UNITED STATES PATENT AND TRADEMARK OFFICE

10/576,673

Kazuhiro Shiroza

Office Action Summary	Application No. 10/576,673	Applicant(s) SHIROZA, KAZUHIRO	
	Examiner Stephanie Jennings	Art Unit 3725

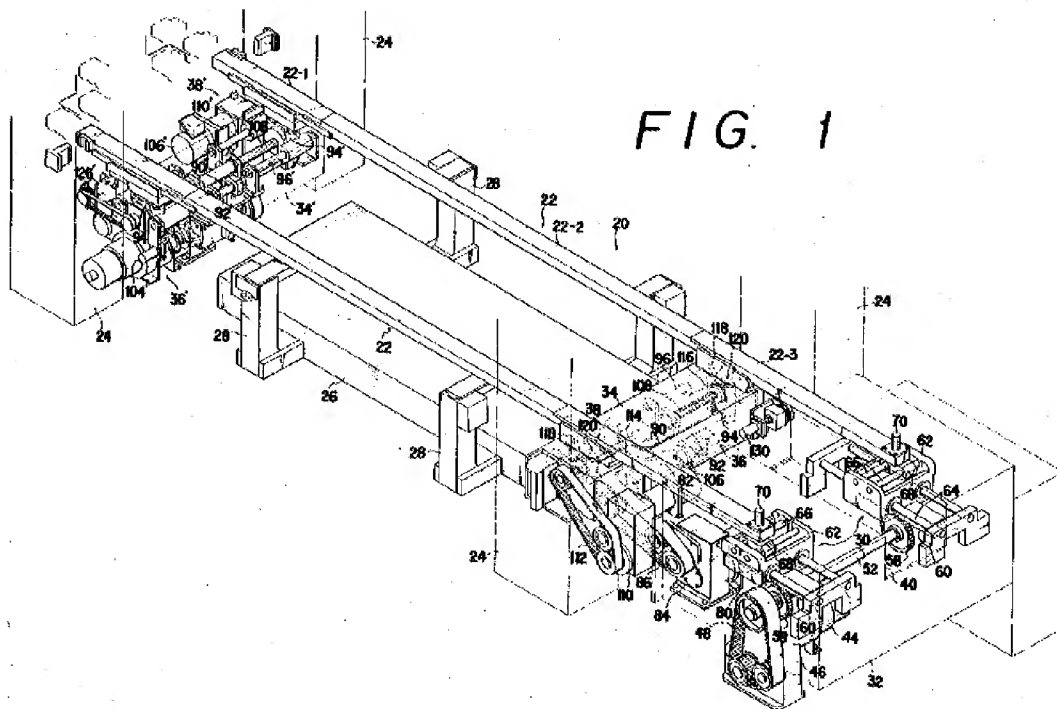
9. Mizumoto anticipates:

10. Limitations from claim 1, a work carrying device (20) of pressing machine, comprising: frames provided on both sides of a moving bolster (26) in a work transfer direction; a pair of bars (22) provided in parallel in the work transfer direction (column 3, lines 11-14); a feed carrier (62) held by each of the bars; a feed drive mechanism (30) provided on each of the bars, the feed drive mechanism driving the feed carrier in the work transfer direction (column 3, lines 42-45); a lift drive mechanism (38) provided in each of the frames, the lift drive mechanism (38) driving the pair of bars in a lift direction so that the bars moves vertically (column 6, lines 33-37); a clamp drive mechanism (36) provided in each of the frames, the clamp drive mechanism (36)

driving the pair of bars in a clamp direction perpendicular to the work transfer direction (column 5, lines 26-42); and a work holder detachably attached to the feed carrier for holding a work (column 4, lines 42-44).

11. Limitations from claim 3, the work carrying device of pressing machine according to claim 1, wherein the feed drive mechanism (30) is provided with a servomotor (44) (column 4, lines 16-18).

12. Limitations from claim 4, the work carrying device of pressing machine according to claim 1, wherein a plurality of the work holders (70) for plural working processes are detachably attached to the feed carrier (62 or 68) (column 4, lines 42-44).

13. Limitations from claim 5, the work carrying device of pressing machine according to claim 1, wherein the pair of bars include fixed bars supported by the clamp drive mechanism (36), and movable bars (94) capable of being detached from the fixed bars (22) (column 5, lines 40-42).

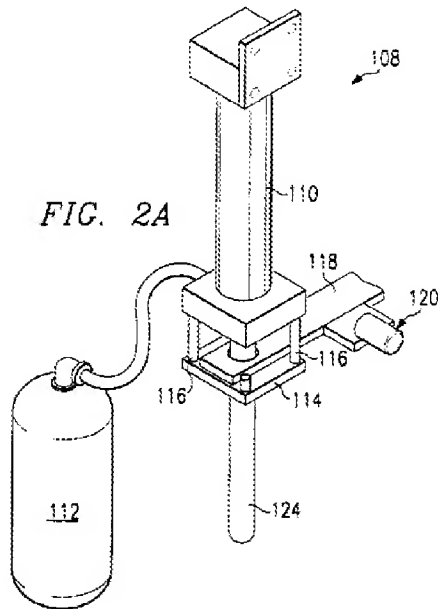
21. Vanderzee teaches:

23. Limitations from claim 2, the work carrying device of pressing machine according to claim 1, wherein the feed drive mechanism is provided with a linear motor (120) (column 6, lines 54-59).

24. It would have been obvious to one of ordinary skill in the art to combine Vanderzee's invention and Mizumoto's invention because the linear motor ensures regulation of the feed drive mechanism.
